SITE PLAN
NATHAN COWAN
ADDRESS: 1369 SPRINGDALE ROAD
LAND LOT 54 OF THE 18 TH DISTRICT DEKALB CO. GA.
LOT 11
BLOCK 36
UNIT:
DRUID HILLS S/D, PB 7, PG. 77
DATE: 01/22/2021

PUBLIC NOTICE

AN APPLICATION FOR A CERTIFICATE OF
APPROPRIATENESS FOR

1369 Springdale

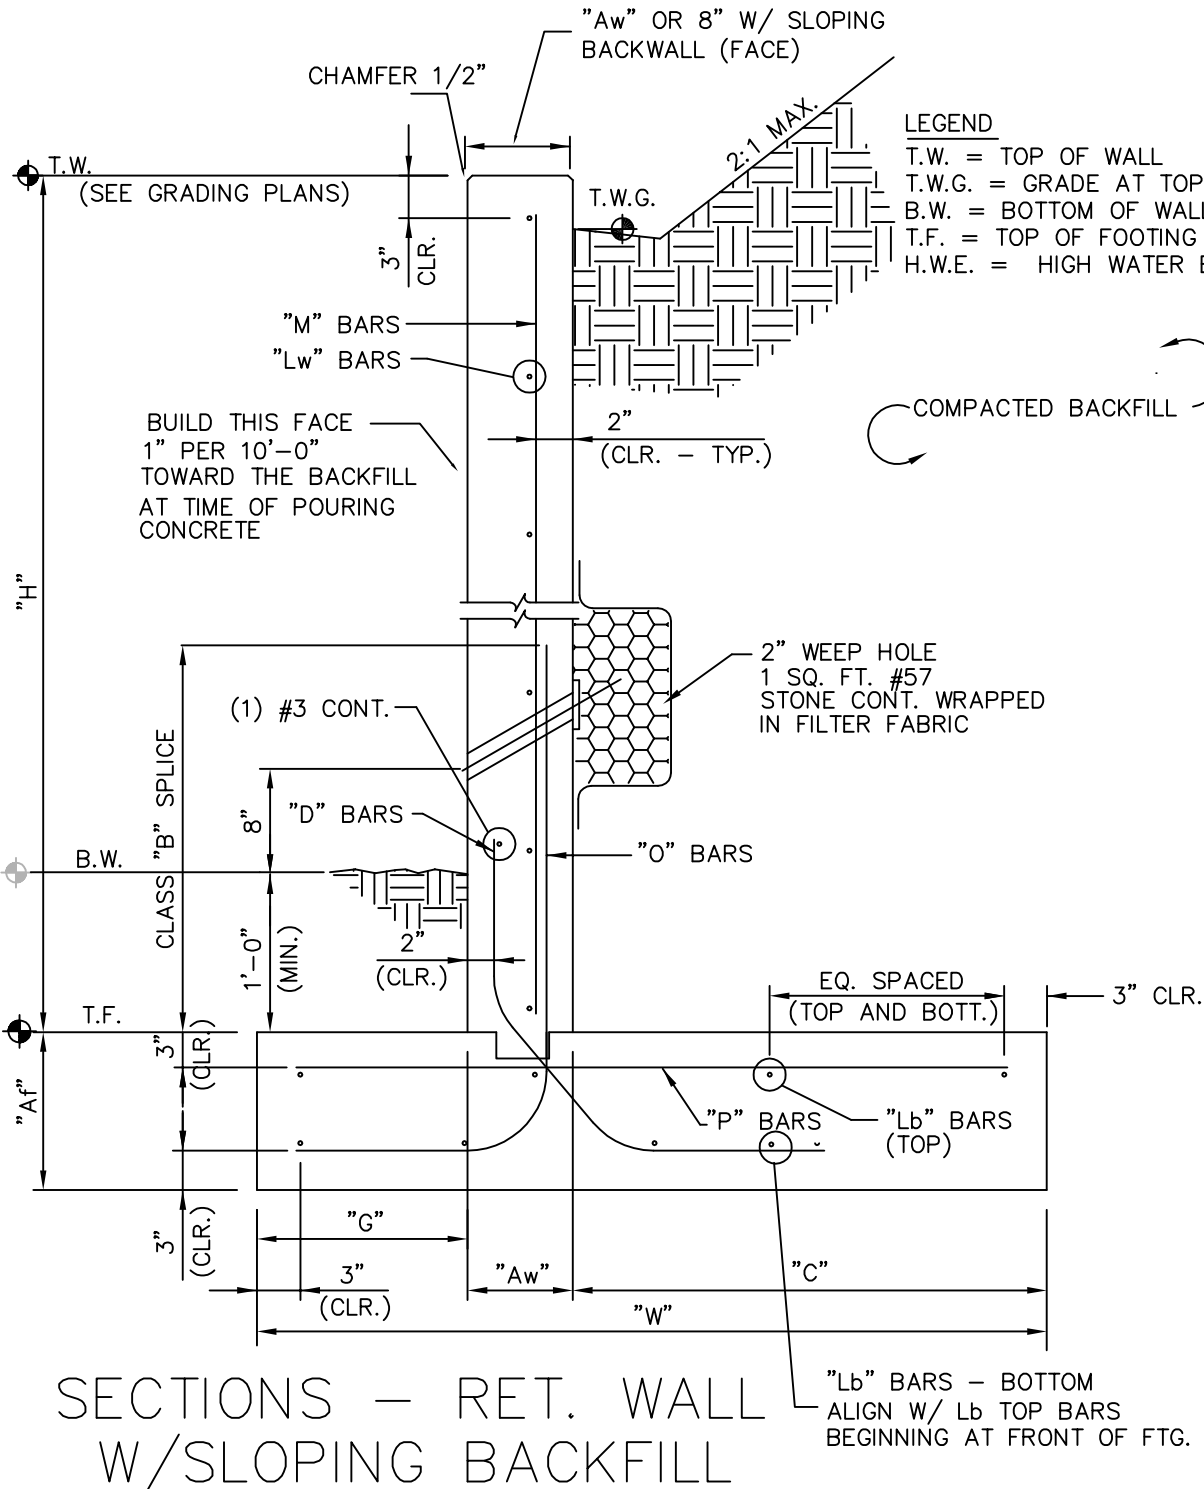
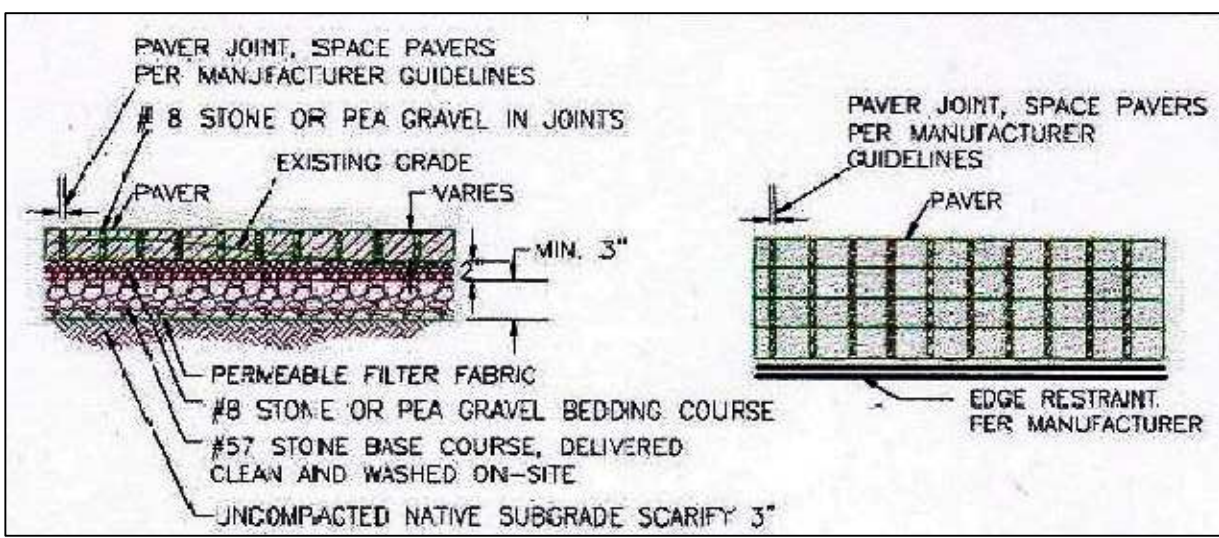
Your site plan shows the wall along the sidewalk being 2' tall for its whole length. Looking at the slope, I would think you would need a taller wall. Can you comment?

We were keeping the approx. 29" ht. wall continuous to the driveway's slope. At the left side of our entry porch the grade will be at 886 and will slope to approx. 884 as it nears the driveway. So the top of the wall where it attaches into the house is at 844.45. As that wall moves towards our landscape steps (towards Springdale), the wall will follow the driveway slope and end up at 880 bo.w., and as it turns back to the front yard and will then start increasing with the step risers. The grading at the planting area (that the wall creates) will have to have a berm that takes in to account the 2 foot drop right to left and the 4' drop from the corner of the entry porch to the inside corner of the 1st lower tread of the landscape steps. Looks like I forgot the 884 grade line at that location that would illustrate that.

The wall in front of the landscape steps connecting into the front sidewalk wall would simply follow the remainder of the driveway slope to the street at our 29" height. The neighbor's existing sidewalk wall is at 29" ht. now.

1
A2.1
PROPOSED FRONT ELEVATION
1/4" = 1'-0"

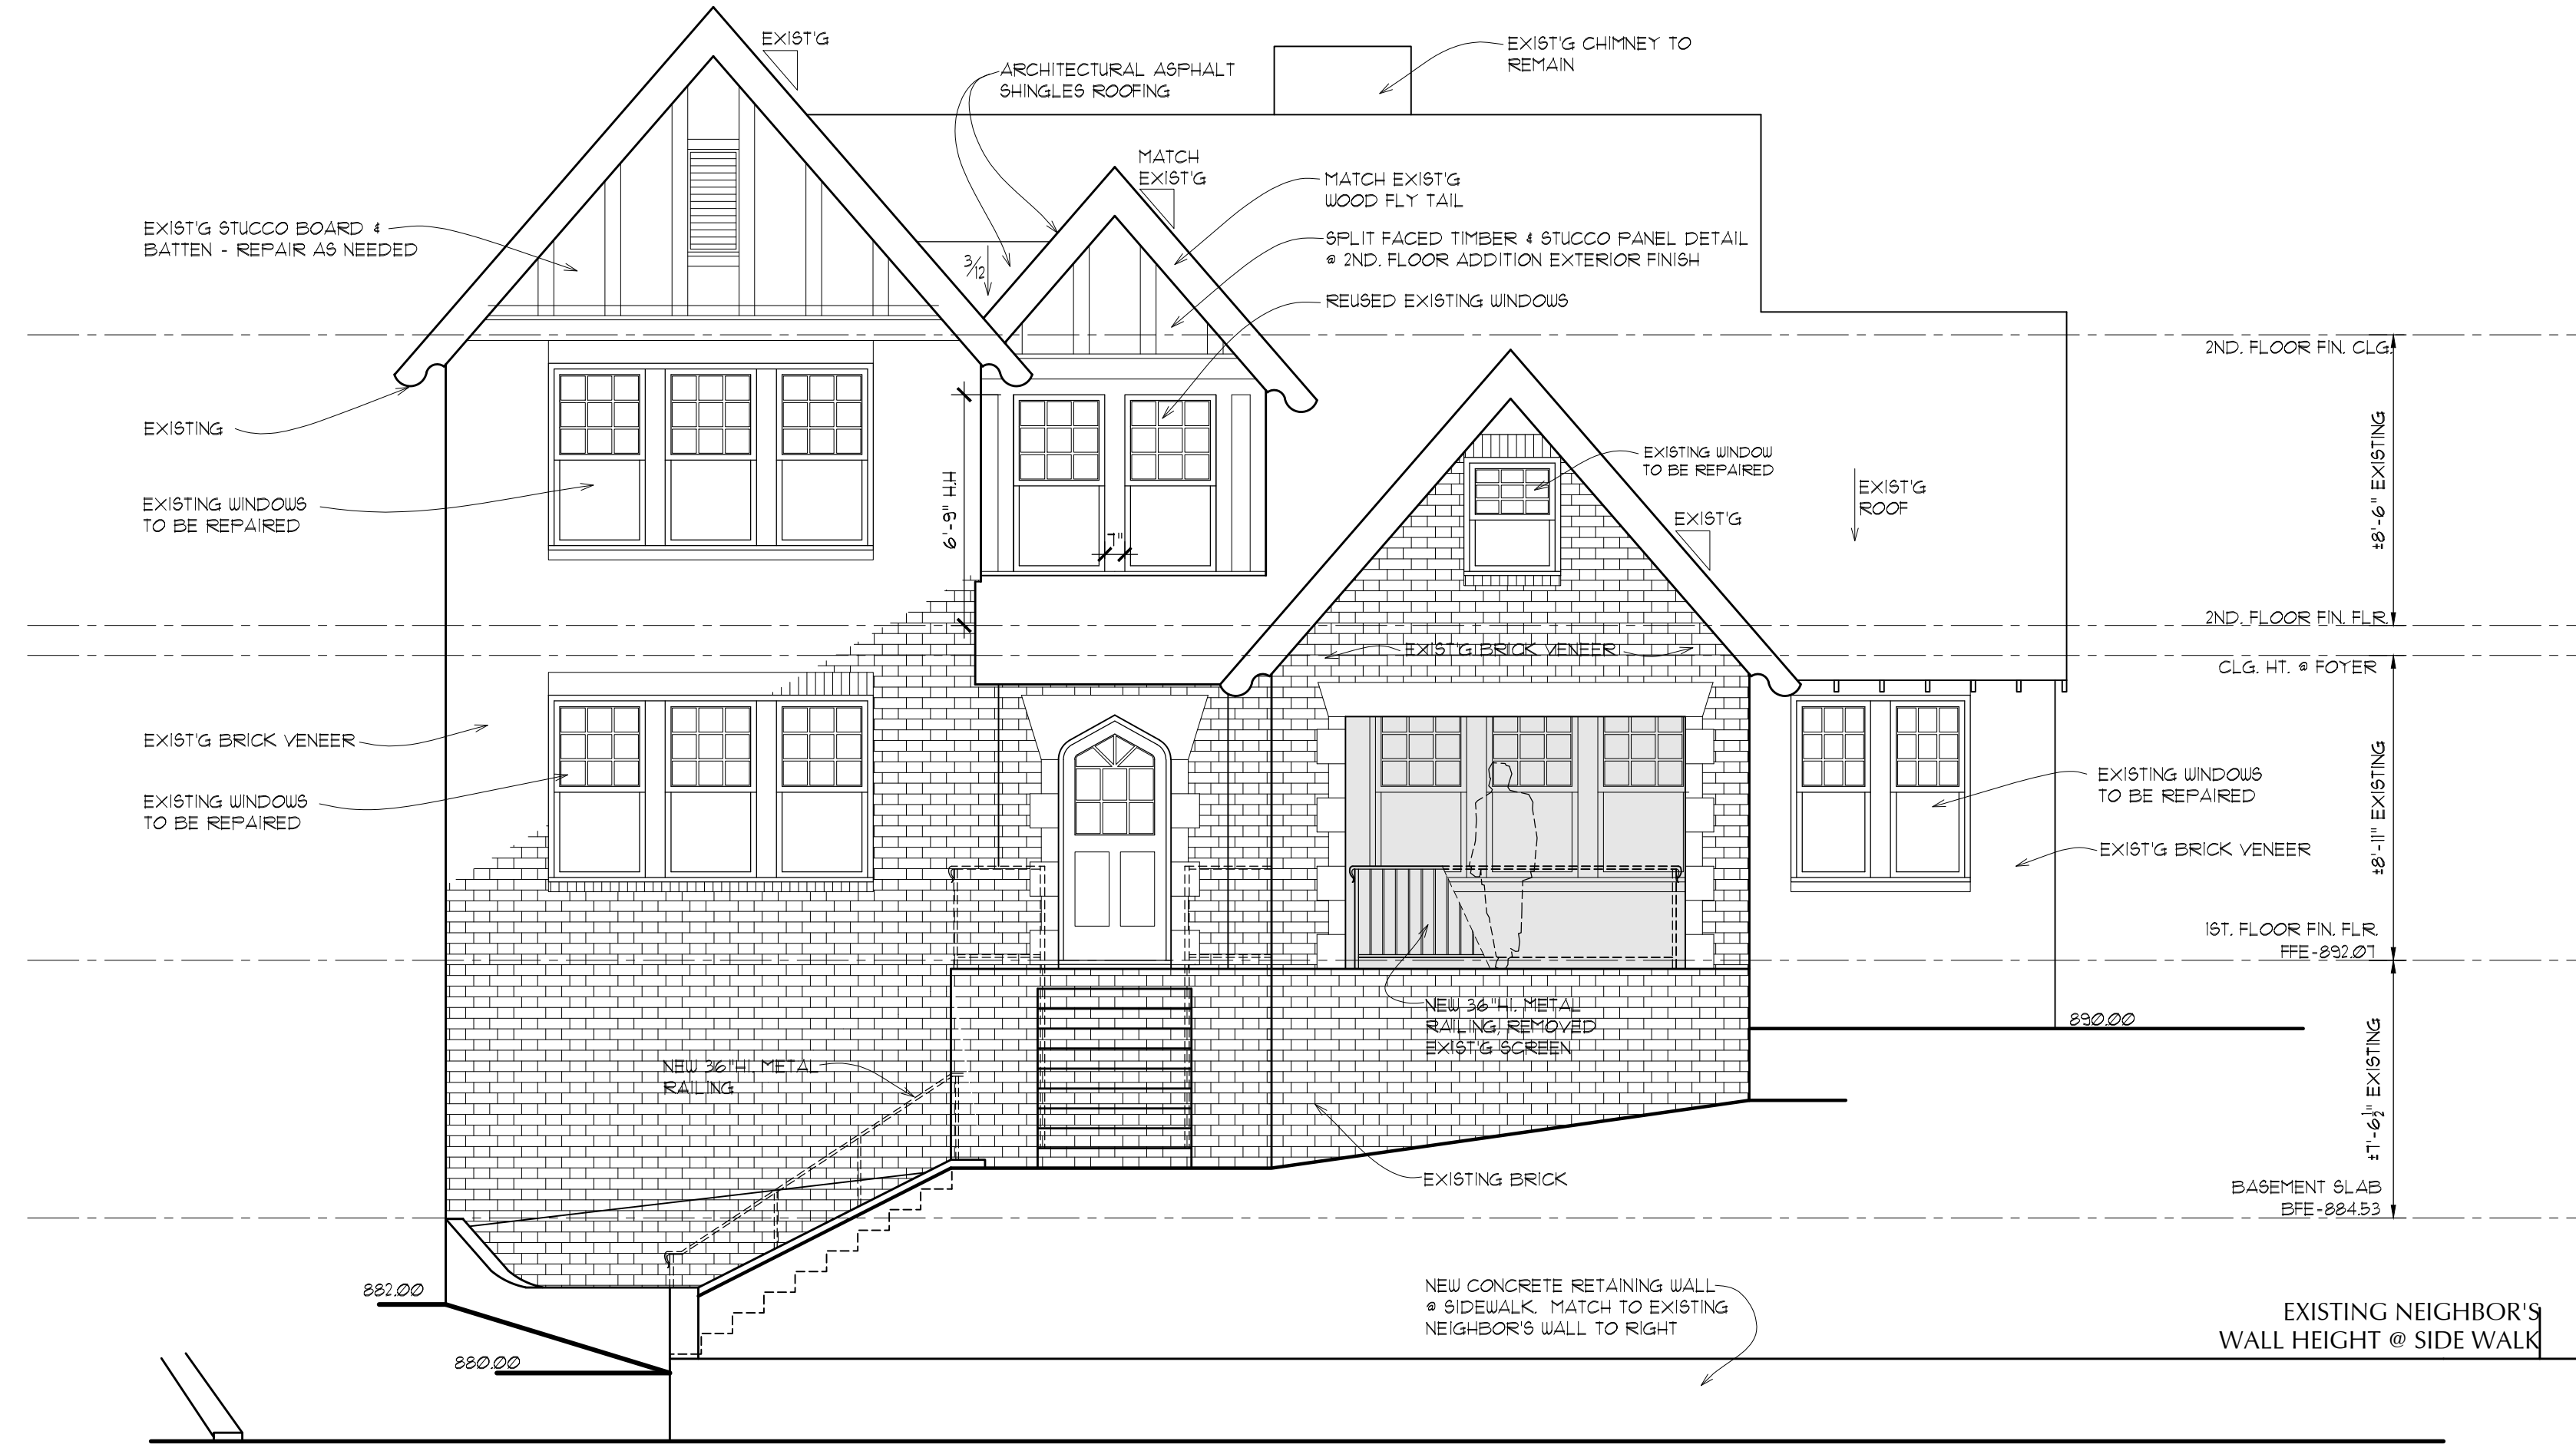
Attached is a Front Elevation of 1369 Springdale that I hope addresses some of the commission's concerns. I also attached some pictures of what we are now proposing for our front entry steps and railing. We will provide better details for our application but wanted to get the conversation going with you on what we are proposing as soon as possible.

I think those were the areas of concern as well as the grading/wall heights and garage detailing. The

HATCHED AREA SHOWS EXISTING WALLS & STEPS TO BE REMOVED.
EXISTING BRICK VENEER @ BASEMENT WILL BE EXPOSED.
HOPEFULLY THE ORIGINAL BRICK EXISTS OR CAN BE REPAIRED
W/ RECLAIMED/REUSED BRICK.

BRICK SIDE WALL @ GRANITE TREADS
BRICK TO BE RECLAIMED RE-USED AND FILL IN
WITH NEW BRICK MATCH SIZE AND COLOR.
OR GRANITE VENEER

At the original brick veneer that will be exposed once the existing concrete steps are removed, we are hoping the original brick exists and can be cleaned and repaired. If not, we hope to reclaim and reuse the brick from the demoed existing walls at the steps, and fill in with new brick that matches in size, color and texture as much as possible. The mortar would match to existing as well. If that is not a possibility based off existing conditions we propose a brick water table that sits up against the existing veneer and height aligns with the entry porch's floor. We are thinking it would look better with one continuous line versus stepping it down with the exposed area. Again, we would use as much reclaimed brick as possible but would have to rely on more new brick because of the area involved. We would then plant the area out as much as possible so that the watertable visual disappears as much as possible. We would not turn the water table at the side elevation corner so that over an evergreen shrub disguises the new bricks from the street and driveway. We are hoping not have to do the new watertable but to repair the existing original veneer that may existing behind the concrete steps.

We are now proposing using solid granite treads for our front entry steps instead of brick. See the attached pictures for the finished materials. The side walls would be the reclaimed and matching brick but would be open to using a granite veneer if the commission felt it more appropriate.
